PIC18CXX2 Rev. B Silicon/Data Sheet Errata

The PIC18CXX2 (Rev. B) parts you have received conform functionally to the Device Data Sheet (DS39026C), except for the anomalies described below.

Clarifications/Corrections to the Data Sheet:

FIGURE 21-3: PIC18CXX2 VOLTAGE-FREQUENCY GRAPH (EXTENDED)

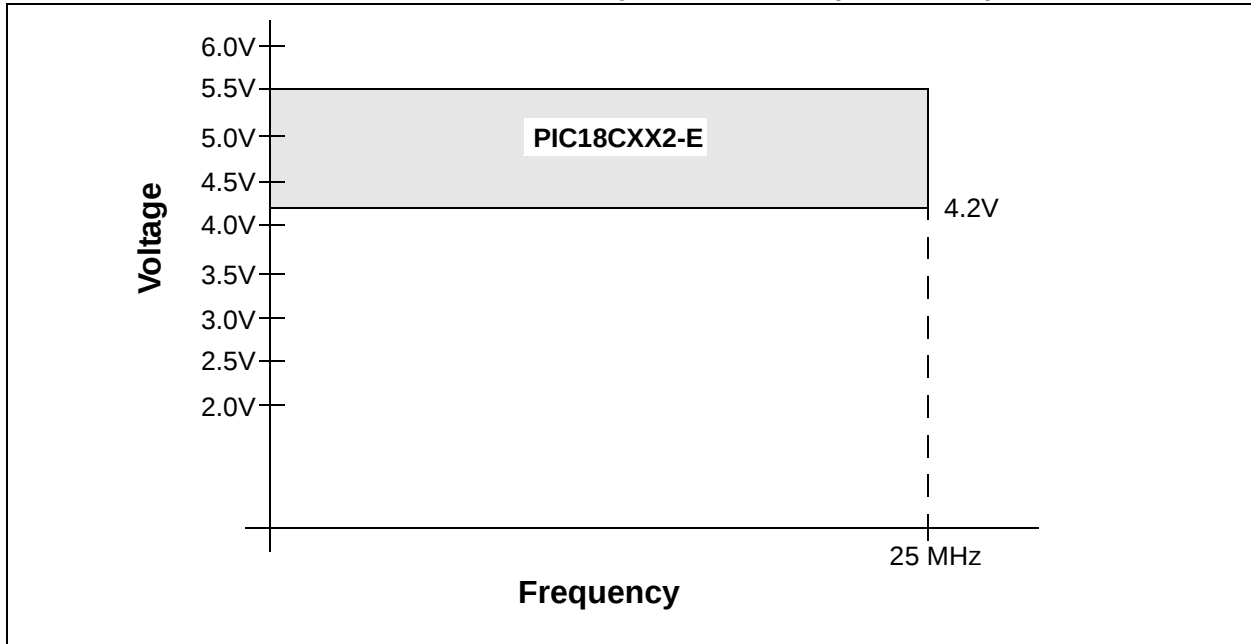
The operating frequency range for extended temperature devices has been changed.

The maximum external clock frequency (EC and ECIO modes) and oscillator frequency (HS mode) for extended temperature devices has been changed to 25 MHz. When the PLL is used

(HS+PLL mode), the maximum clock and oscillator frequency has been changed to 6.25 MHz. Other values of related parameters have changed accordingly.

Figure 21-3 (below), reflecting the voltage-frequency performance of extended temperature devices, is added to the Device Data Sheet:

FIGURE 1: INTERRUPT LOGIC (EXCERPT)

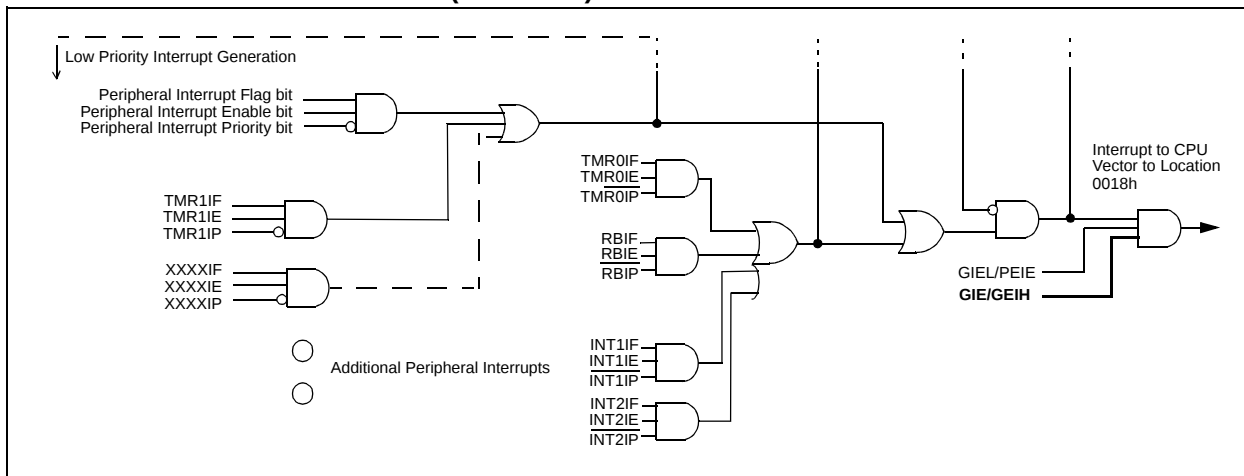
The operation of the GIE/GIEH bit (INTCON<7>) is clarified as follows: when the bit is cleared, all interrupts are disabled. This is regardless of the state of the IPEN bit (RCON<7>), the priority of the interrupt, or whether or not the interrupt is unmasked. This varies from the original description, in which clearing the bit when IPEN = '1' would only disable high priority interrupts.

Also, the interrupt logic funnel shown in Figure 7-1 of the Device Data Sheet is amended with the addition of a GIE/GIEH control line, as shown in Figure 1 (new material in **bold line**).
